SYSTEM: ADVANCED LIGO

SUB-SYSTEM: AOS

PART NAME: OPTICAL LEVER PIER WELDMENT PROTOTYPE

D0900657 AdvLIGO AOS Optical Lever Pier Weldment Prototype PART PDM REV: X-018 DRAWING PDM REV: X-017

NOTES CONTINUED:

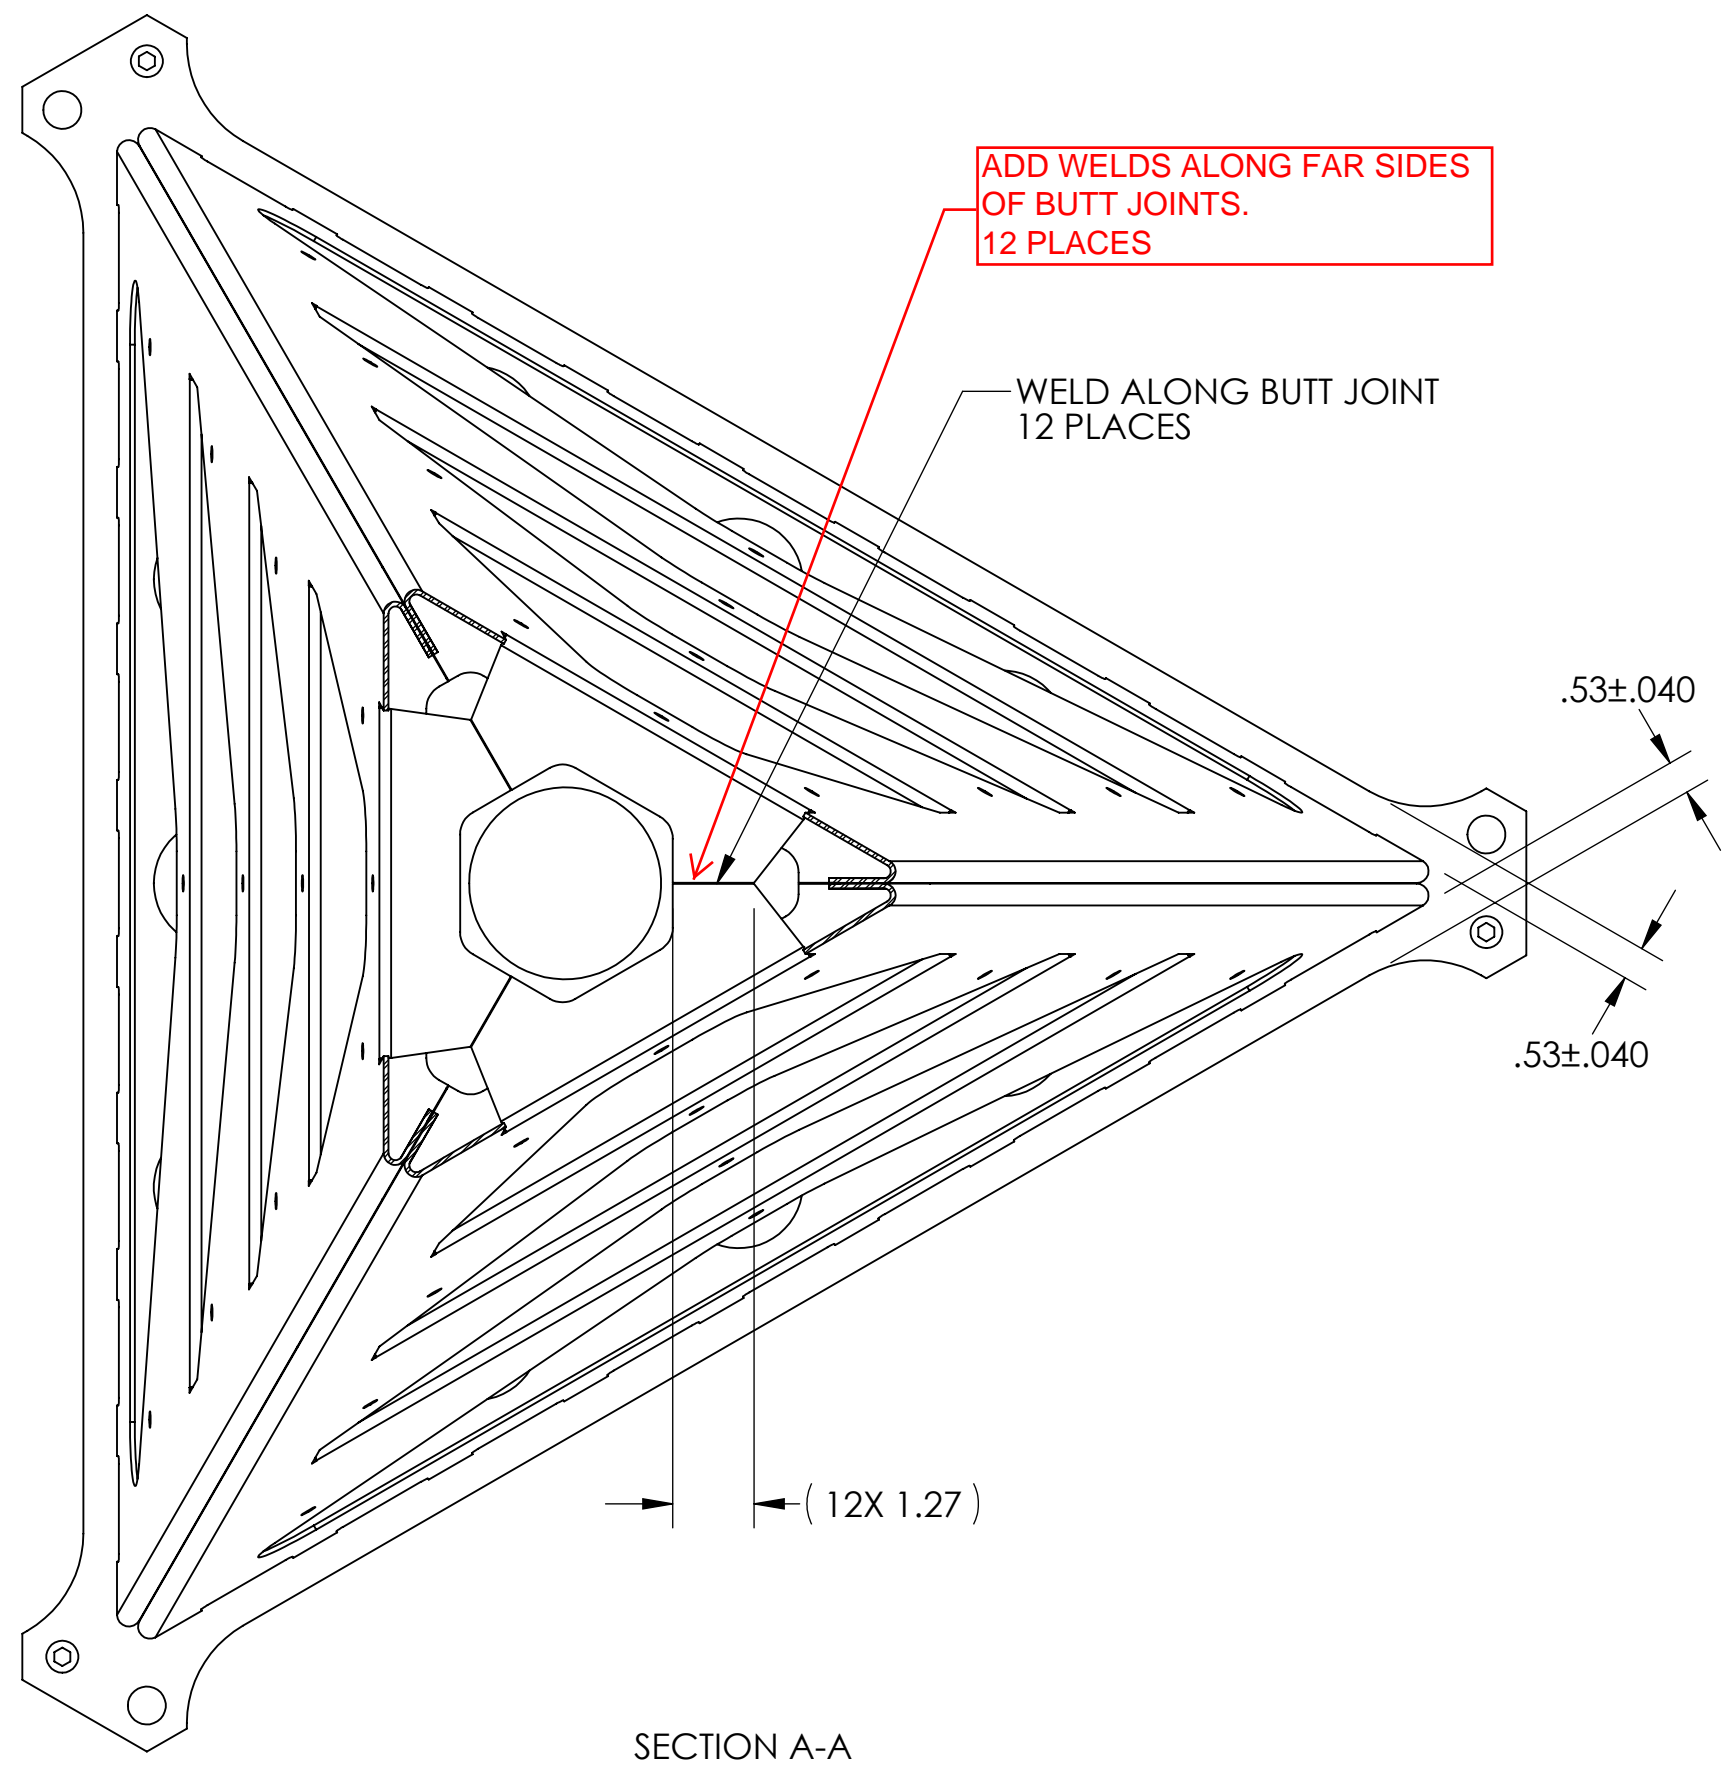
ADD WELDS ALONG FAR SIDES OF BUTT JOINTS. 12 PLACES

WELD ALONG BUTT JOINT 12 PLACES

STITCH WELD ALL ALONG THREE SIDES. 1.4" WELDS, 4.3" PITCH, INCLUDE ENDS

STITCH WELD INNER TAB ENDS ALONG ALL THREE CORNERS. 1" WELDS, SPACED MIDWAY BETWEEN EXISTING OUTER CORNER WELDS, INCLUDE UPPER & LOWER ENDS. (39 WELDS TOTAL)

WELD ALL ITEM 1/ITEM 2 INTERFACES (OUTSIDE ONLY)

WELD ALL ITEM 1/ITEM 3 INTERFACES (OUTSIDE ONLY)
